Proposed new house

New House in Castle Street to the Rear of 5 The Esplanade

The proposed new house is **RECOMMENDED FOR APPROVAL** subject to conditions. Report by Director of City Development.

Proposed Aerial View from Brook Street (looking south)

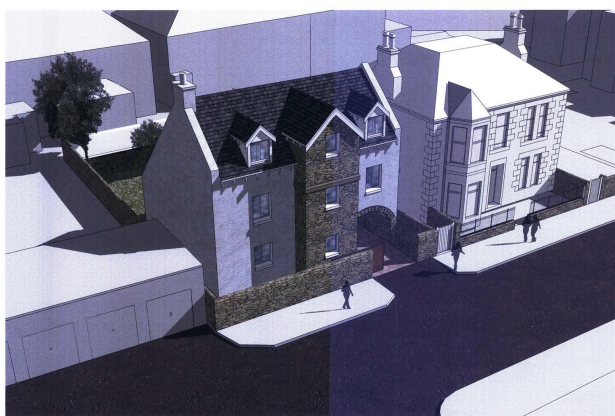
- The new building is out of keeping with the Conservation Area.
- It does not preserve or enhance the Conservation Area.
- The three storeys and features on the front of the house detract from the conservation area.

- The design and materials do not respect surrounding buildings including the white render.
- The design is unduly dominant and does not enhance the conservation area.

- There is too much glass in the structure.
- The modern windows clash with the Victorian windows.
- The building would be out of harmony with the existing residences in Castle Street and would appear to destroy the nature and harmony of this terrace of houses.

The main part of the dwelling has been set back from the road at the front in order to align with the adjacent house at 38 Castle Street. There will be a section protruding to reflect the bay window designs of the some of the nearby properties, including the adjacent property at 38 Castle Street. This section shall be finished in natural stone which helps the proposed dwelling to sit comfortably in the streetscape.

In terms of overall height, the total height to the top of the ridge of the proposed dwelling is approximately 12.79 metres which is the same overall height of the adjacent dwelling to the west. The dwellings to the east which form the long terrace are approximately 13.02 metres to the ridge height and are of two and a half stories high. It is therefore considered to be in keeping with the scale and heights of the other dwellings in the area. The eaves line for the proposed and house to the west are similar in order that the proposed building does not result in discordant building lines. It is accepted that the proposed windows are of a smaller scale to the front elevation than some of the dwellings in the area but it is also noted that they are of comparable size and appearance to a large number of other properties and so it is considered that there is no necessity for the window pattern of 38 Castle Street to be repeated exactly.

The proposed design approach is such that the dwelling would appear as a 2 and a half storey dwelling from the front, dropping to single storey at the rear. The total height to ridge is comparable with the adjacent dwelling to the west and the long line of terraced properties also located to the south side of Castle Street to the east of the site.
